UNITED STATES PATENT AND TRADEMARK OFFICE

Office Action Summary	Application No. 10/662,888	Applicant(s) BILLET, JACQUES
	Examiner Korie H. Chan	Art Unit 3632

DETAILED ACTION

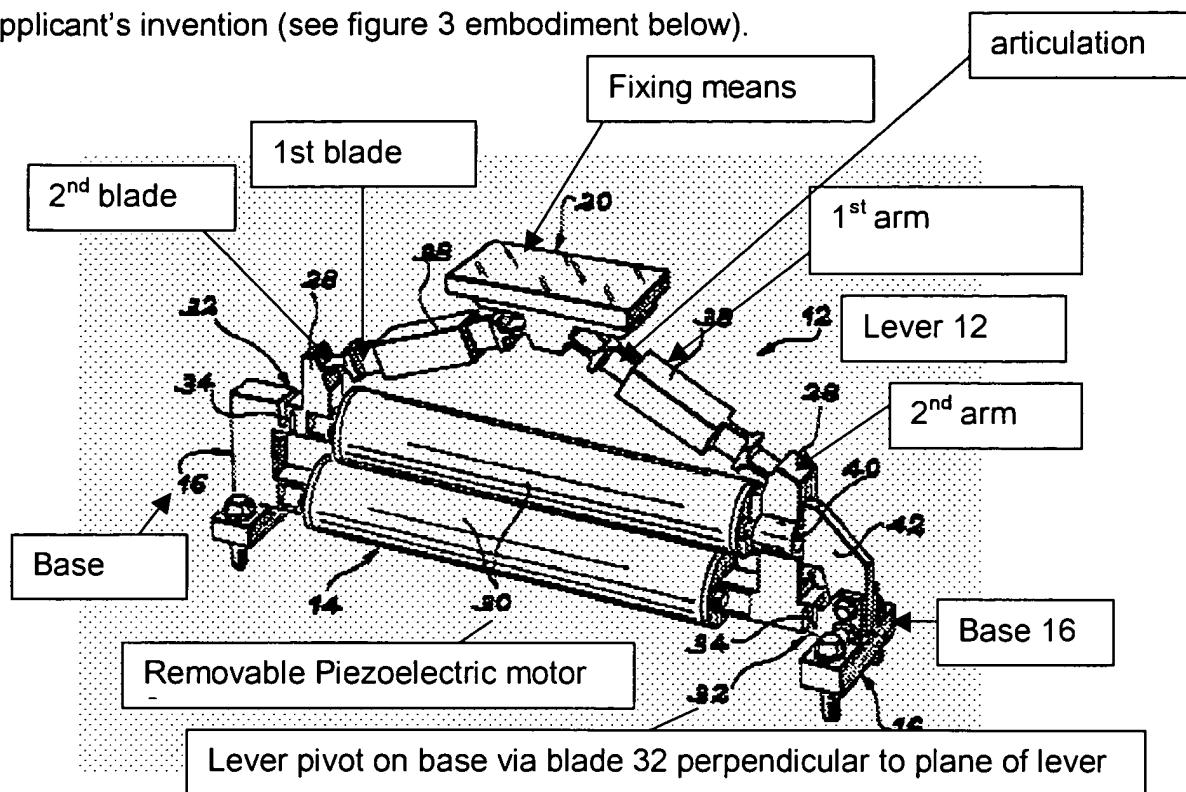
Claims 1-19 are rejected under 35 U.S.C. 102(b) as being anticipated by Bailly et al (French patent no. FR 2,773,890). Bailly et al disclosed all the claimed features of applicant's invention (see figure 3 embodiment below).
